N1918A-01

S E R V I C E N O T E

N1918A Power Analysis Manager

Calibration Due Date feature in N1918A revision R01.02.00 does not work with U2000 Series USB power sensor with firmware revision A1.01.02

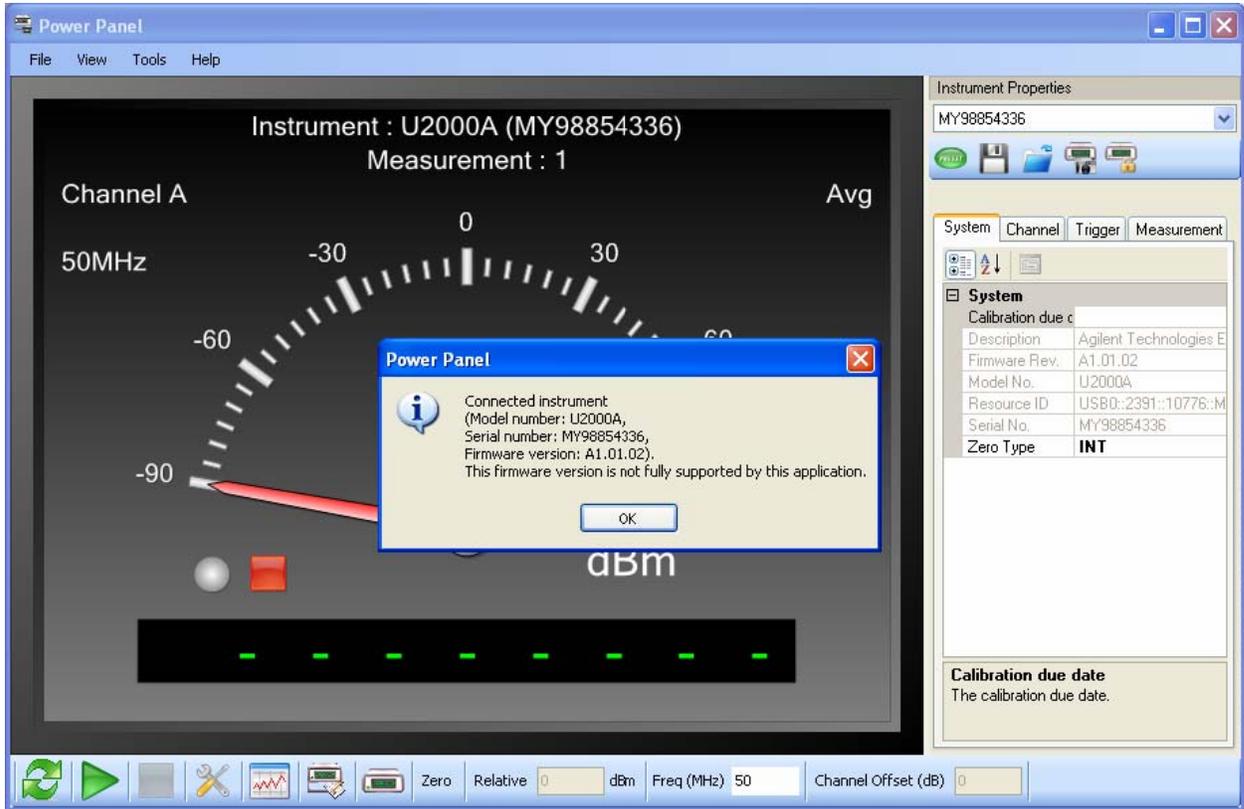
Error message as shown below will appear and user is unable to key in the due date when N1918A software revision R01.02.00 is used with U2000 Series USB power sensor with firmware revision A1.01.02.

Please download and install the latest revision of N1918A software from Agilent web site.
